Village of Arlington Heights
Plan Commission
Board Room
Arlington Heights Village Hall
33 S. Arlington Heights Road
Arlington Heights, IL 60005
October 25, 2017
7:30 PM

- A. St. Edna Church - 2525 N. Arlington Heights Rd. - PC#17-010
PUD Amendment

File Number: PC# 17-010
Project Title: St. Edna's Catholic Church
Address: 2525 N. Arlington Heights Rd.
PIN: 03-17-101-019

NEW ADDITION AND INTERIOR RENOVATIONS TO:
ST. EDNA CATHOLIC CHURCH
2525 N. ARLINGTON HEIGHTS RD. ARLINGTON HEIGHTS, IL 60004

DRAWN: _____	PLAT DATE: 05/01/2017
CHECKED: _____	
JOB NUMBER: 1020	C-4

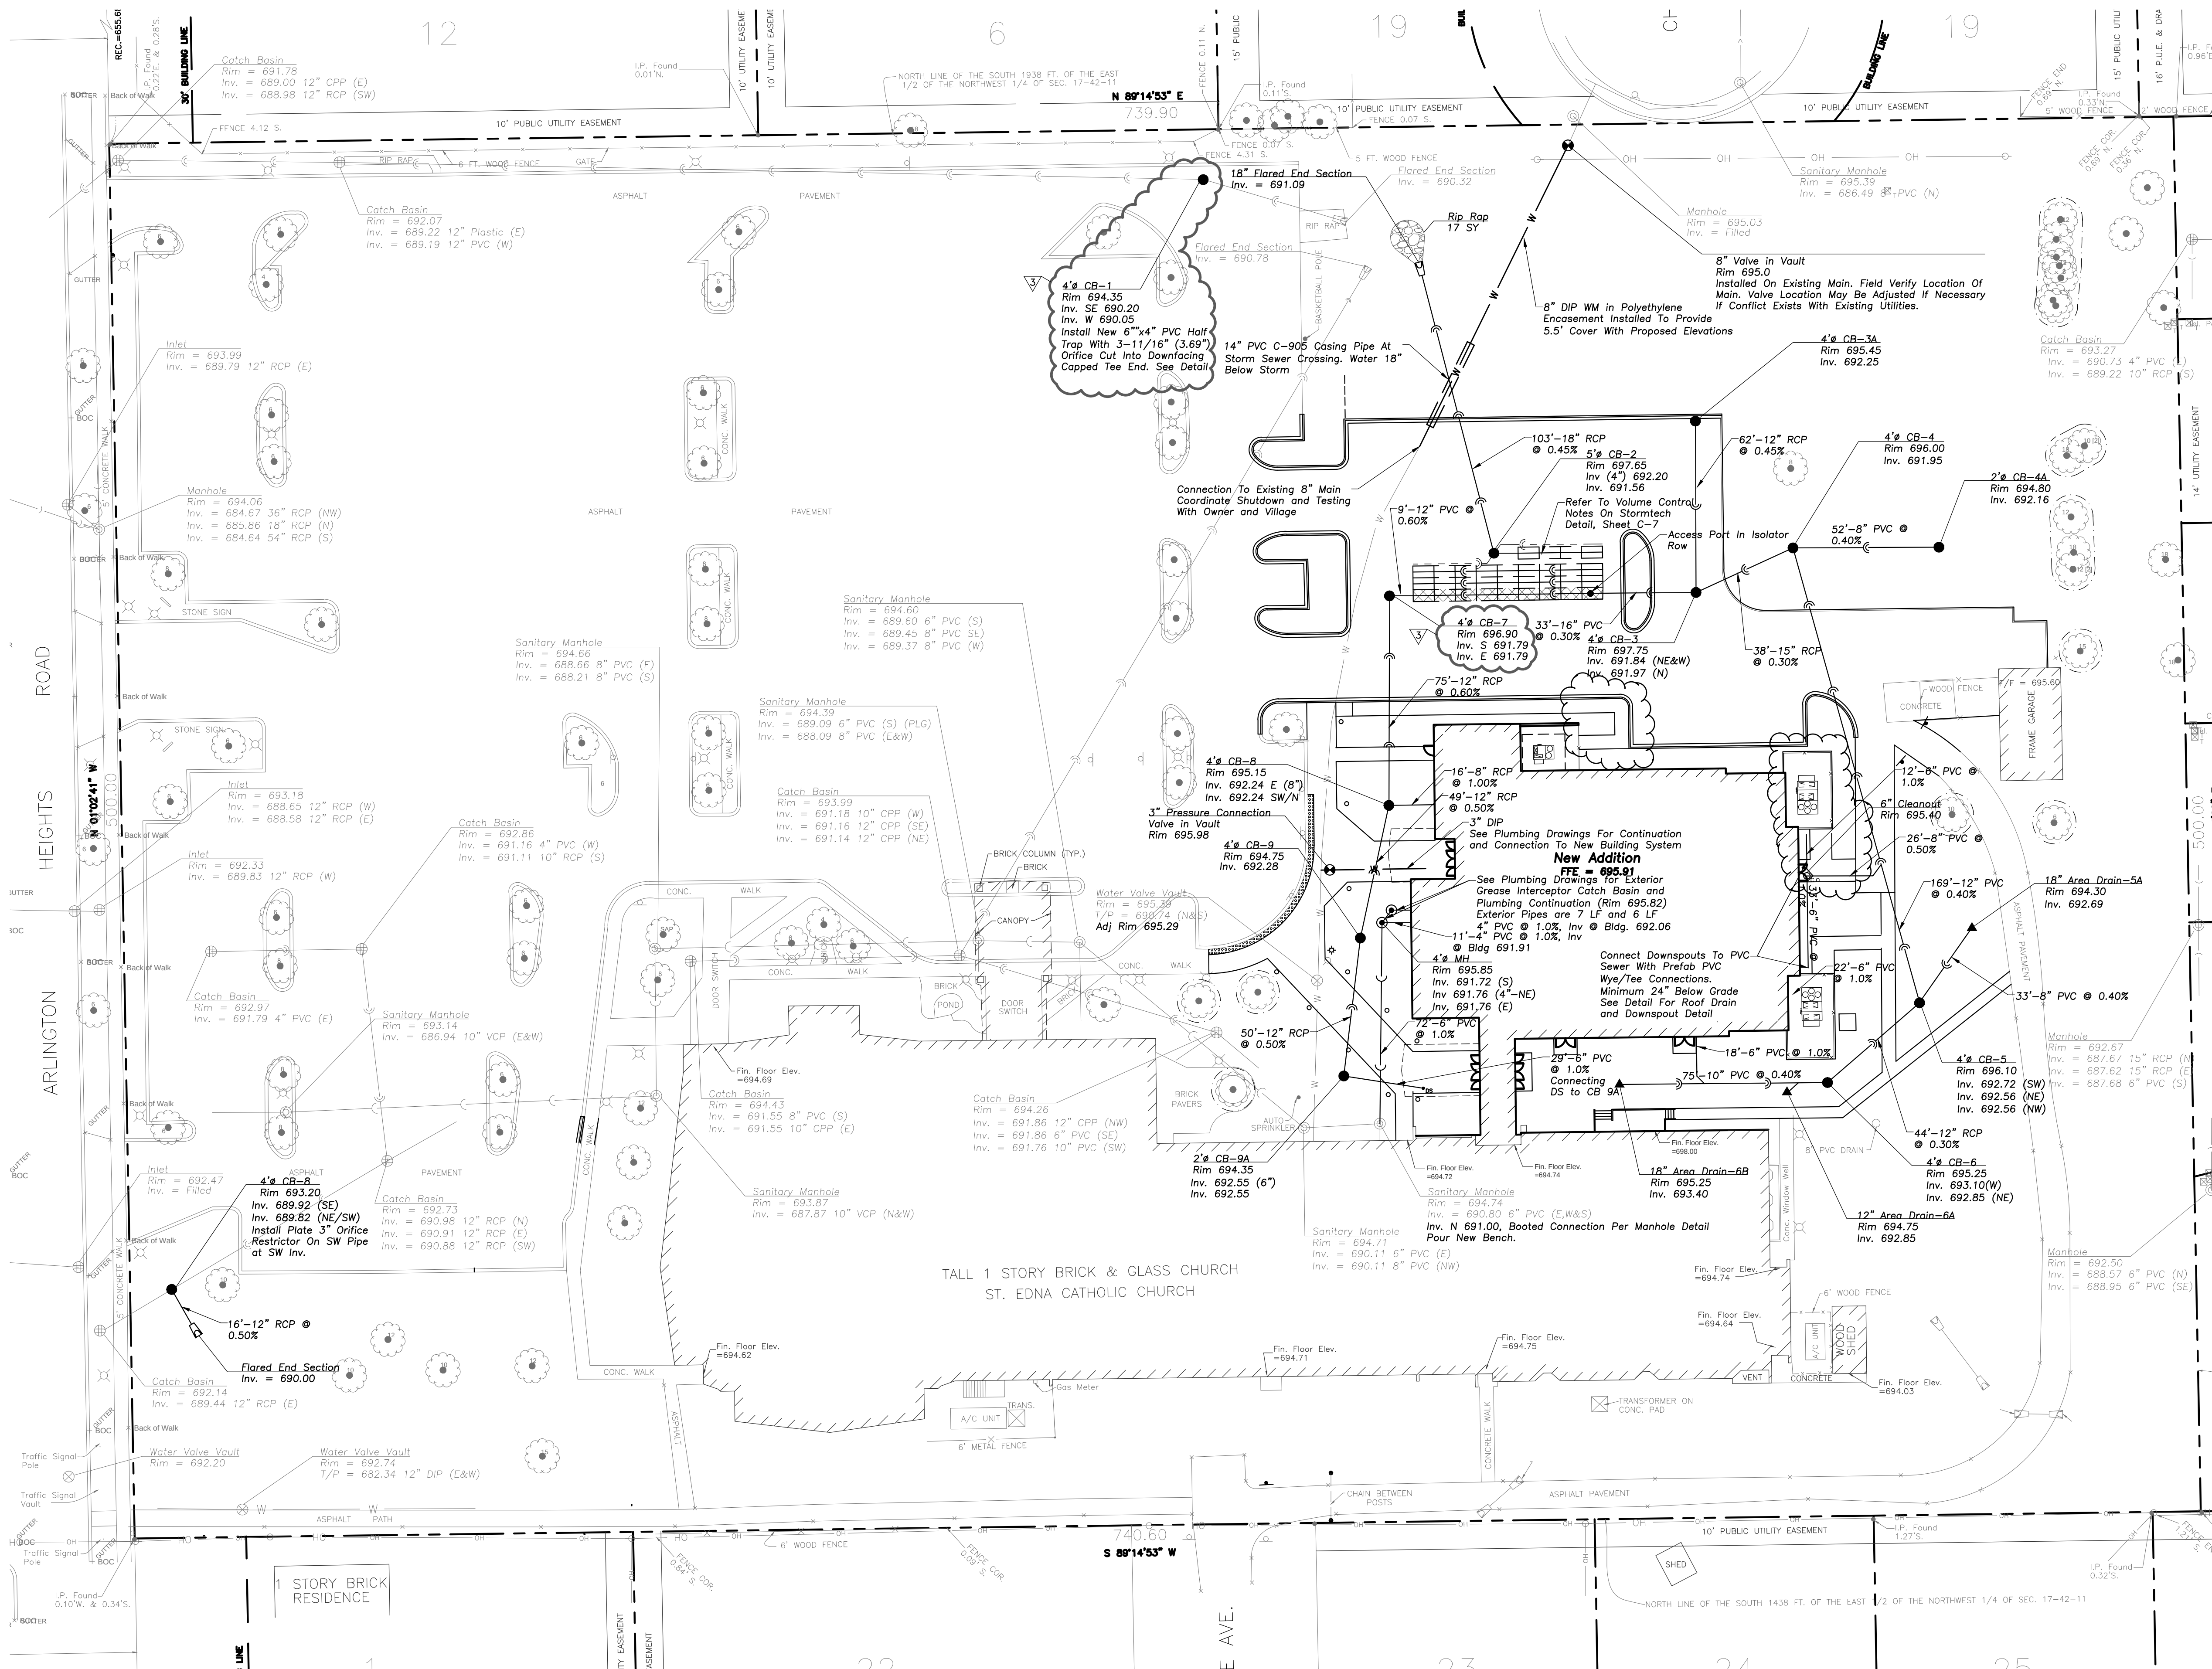
As stated, the detention will be designed to accommodate both Arlington Heights and MWRD requirements and all calculations will be provided prior to final approval. The existing plate restrictor will be removed and replaced with a half trap orifice restrictor. The existing manhole at that location will be replaced by a catch basin. The location and size of the restrictor and structure are shown on sheet C-4. A detail of the restrictor structure is on sheet C-6.

- 1) Illustrate on Civil Plan Sheet C-4 where the meter vault will be placed.
- 2) Provide a detail specific to the water meter vault.

LANDSCAPE PLAN
DRAWN: **DRM** PLOT DATE: **6/23/2017**
CHECKED: **DRM**
JOB NUMBER: **1722**
L1.0

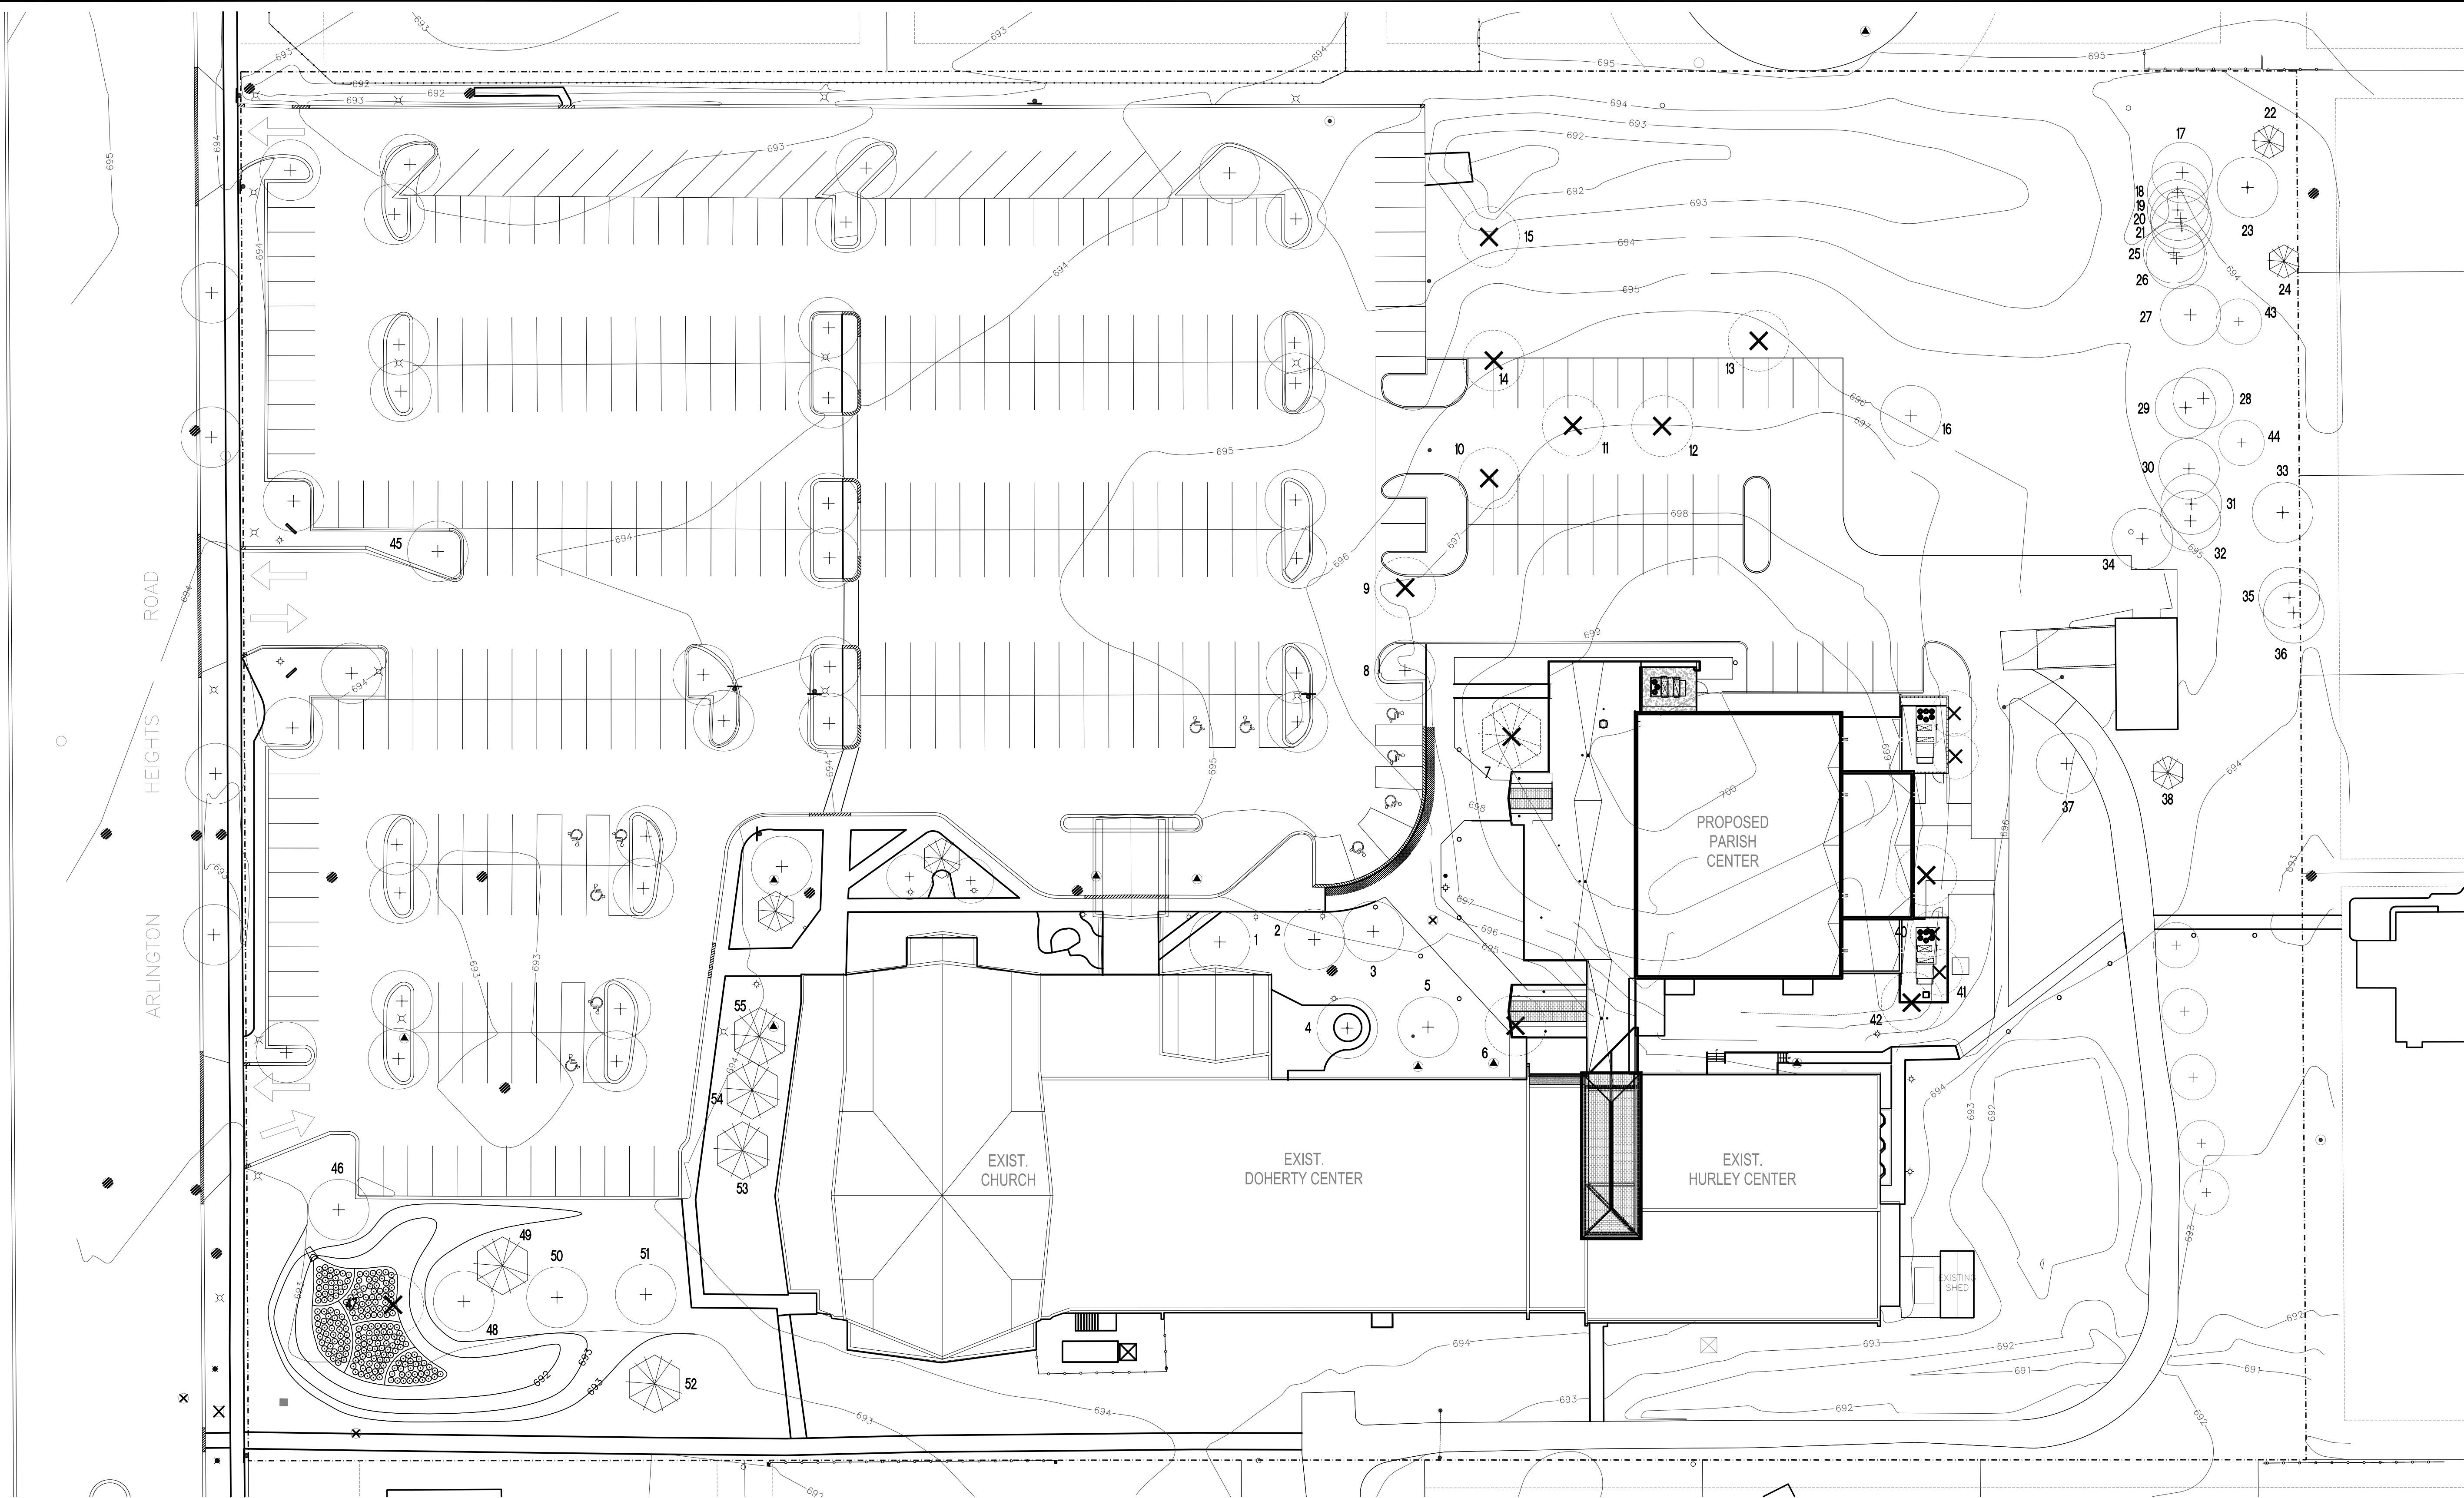
parking total from 45 spaces to 44. Please see the attached architectural site plan or the landscaping plan (L1.0).

Landscaping has been added to the east side of the proposed lot. Please refer to the attached landscape drawing L1.0 for proposed plant types.
